REDINGTON FROGNAL NEIGHBOURHOOD FORUM

2025/1350/P: 35 Hollycroft Avenue - object

Lost rivers and ponds from Arup Google Earth map

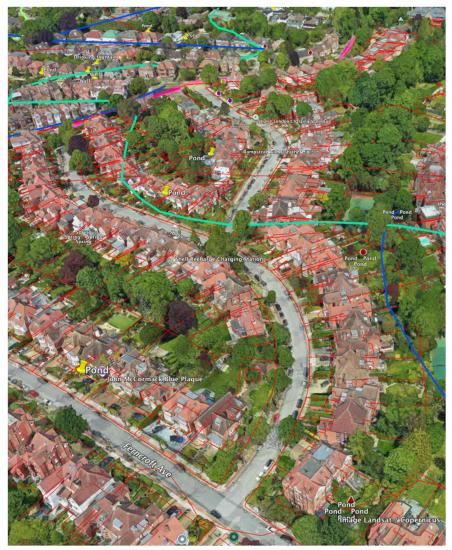
The site is in an area with much underground water where, previously, there had been many ponds nearby. Appropriate mitigation might therefore include the excavation of a natural wildlife pond to support the bats which commute and forage in the area.

The photo above is from the Google Earth map produced by Arup. This can be viewed on the Forum website at:

If Camden is minded to grant consent, the Neighbourhood Forum requests mitigation for loss of soft natural surface.
